## **Urban Design Committee Agenda**

Urban Design Committee  
Staff Report  
5331-3 Roose St./Neighborhood Design Standards  
Agenda of August 4, 2015

"Roose Place" development, built in 2014

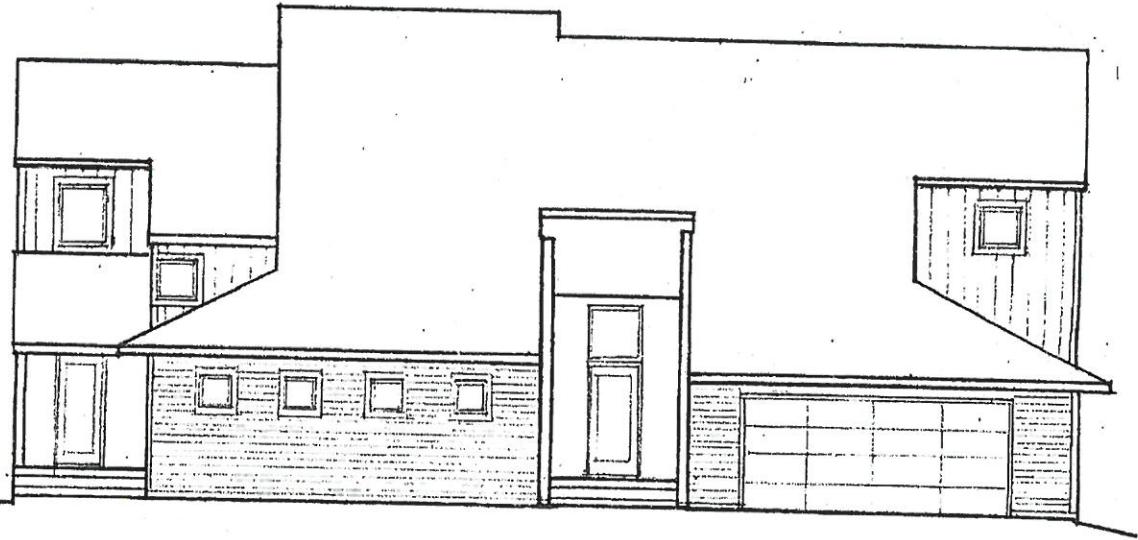
Last year's "Roose Place" construction features a long, linear site along the creek and the pair of houses face north, with north-facing garages at the center of the design.

The façade garages are not a feature of a majority of Roose St. homes, but in this location they were evaluated as not having direct impact on that streetscape. Therefore the Roose Place houses were found to be consistent with the Neighborhood Design Standards.

Site Plan for 5331-3 Roose

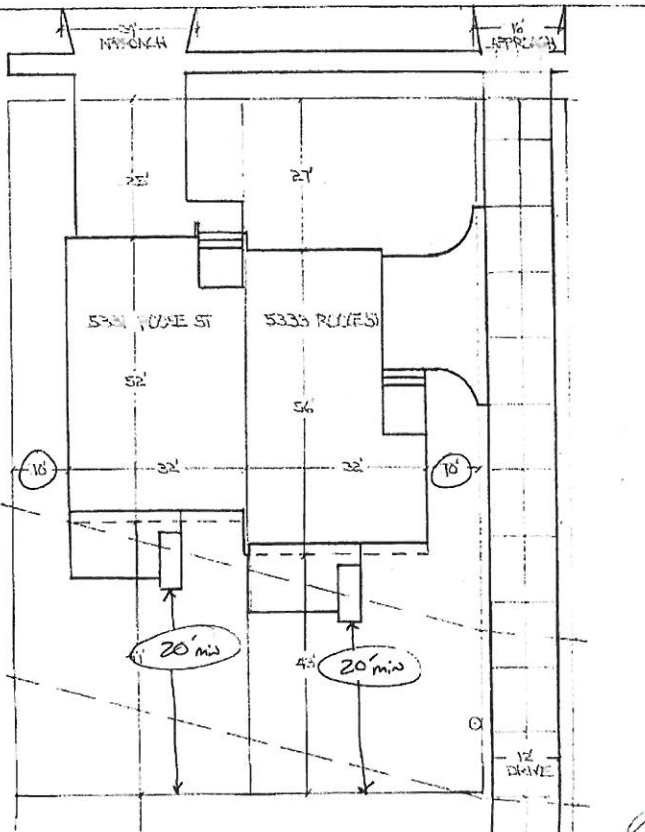
The current proposal for two more townhouses directly on Roose has been directed to the Urban Design Committee because it would be located directly on Roose St. and also proposes a façade garage door for one of the units. The Neighborhood Design Standards call for façade garage doors to be located at least 5 feet recessed when there is no prevalent pattern in a setting (same and facing blockfaces).

The proposed design serves only the west unit's garage directly from Roose, while the east unit's garage would face east and be accessed off the Roose Place entrance drive.

The proposed design is strongly related to the existing Roose Place homes, although adapted to a very different lot. (The diagonal dotted lines on the site plan depict an easement that further constrains the buildable area.) The Roose Place houses are attractive in appearance and establish some context for the proposed construction, within the diversity of house types along Roose Street.

Staff recommend that within the diverse house types of this setting, allowing the proposed design adds to rather than detracts from the context. It proposes an innovative design for a challenging infill site. We recommend that it can be approved by Urban Design Committee as meeting the intent of the Neighborhood Design Standards.
